Permit or receipt no: 68-81 Fee Paid 40⁰⁰ US Date 6/1/81
Installation for CARILL MCCONNELL Phone _____
Current mailing address PO Box 171 SALMON ID. 83467
Legal description: Township _____ Range _____ Section _____ 4Section _____
Subdivision Name MIDSTREAM MEADOWS
Directions to property APPROX. 3 MILES UP SANDY CREEK - W 1/2 1/4

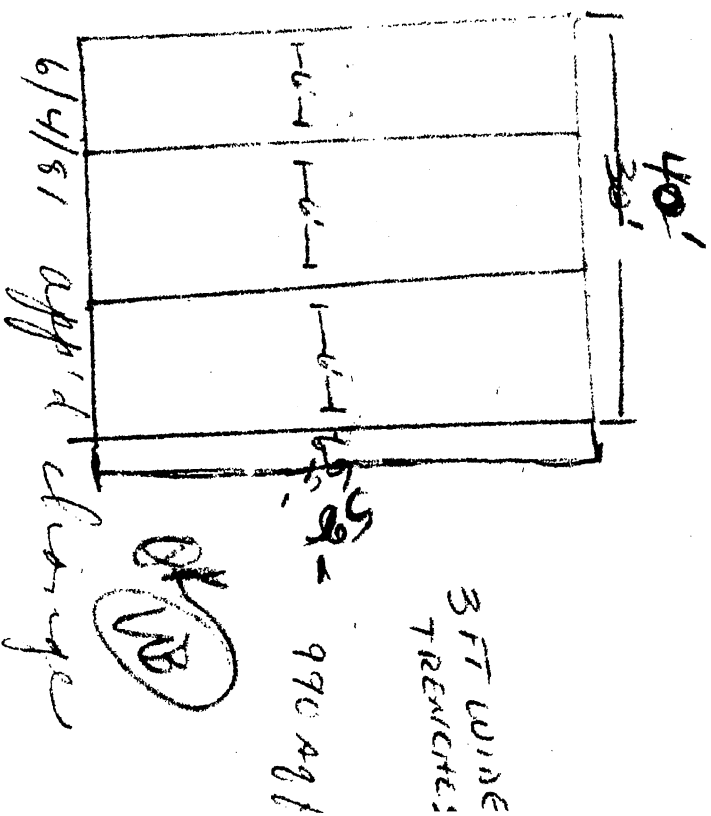
- 40'
30'
-
- 3 FT WIDE
TRENCHES
- 16' 16' 16'
- 976 sq. ft.
- OK VJB
- 6/4/81 app'd change

A) ☒ 4 foot separation between bottom of drainfield and highest bedrock or subwater.
B) ☒ 50 FT from any canal or ditch, 300 FT from any stream or impoundment.
C) ☒ 100 foot separation between well and disposal area.
D) ☒ 1000 square footage of disposal area required. Dimensions 2030' x 4069' x 3 FT WIDE
E) ☒ 1000 gallons minimum size of septic tank needed.
F) ☒ Other: USE SCHED 40 ABS AT INLET; OUTLET OF TANK, 1/2 TO 2 1/2 INCH CLEAN ROCK
IN TRENCHES. CALL 756-2437 FOR INSPECTION PRIOR TO COVER OR USE.
